Flat 4 64 Lawford Road London NW5 2LN

12th March 2017

We are writing to object to the planning application 2017/0839/P for Upper Flat, 75 Bartholomew Road London NW5 2AH.

Overlook into Window 1 - Existing

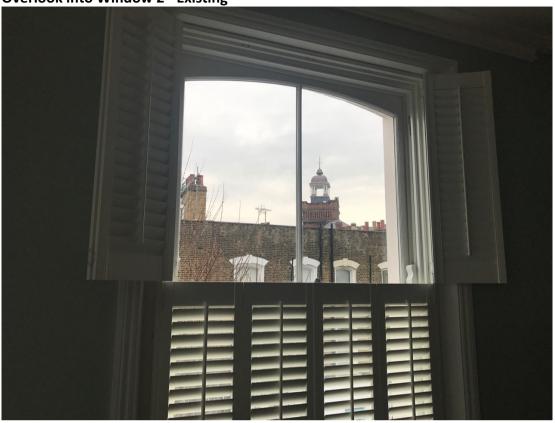
The proposed roof extension and terrace would have direct line of sight into our living room and kitchen area, even if our half height shutters were fully closed.

The images on the following pages show the extent to which the proposed roof extension and terrace would overlook our living room and kitchen area. They show both the existing

situation and where the proposed designs show the roof extension would lie (indicated in red). Please note that the red areas have been drawn on visually from looking at the proposed designs and will not be as accurate as the scale drawings.

We would also like to point out that the red areas indicated in these drawings show the extent of just the roof extension, which is set back from the front of the property. The overlook from the terrace, in front of the roof extension, would be *even more* significant.

Since the introduction of the Bartholomew Estate Conservation area, the top floor of the Duke of Cambridge pub has enjoyed a largely uninterrupted outlook to the east, including the historic tower of the Camden School for Girls. The proposed development would significantly reduce this visual amenity by reducing the amount of open sky and obscuring the historic tower with a more overbearing modern metal, glass and brick structure. (This is illustrated in the previous picture of Window 2).

If, for example, the terrace were to be located at the rear of the property (as per Camden Planning Guidance's own recommendations) then it would not overlook residential properties. Furthermore, if the design of the roof extension were to be lowered then it would have less impact on our privacy and outlook.
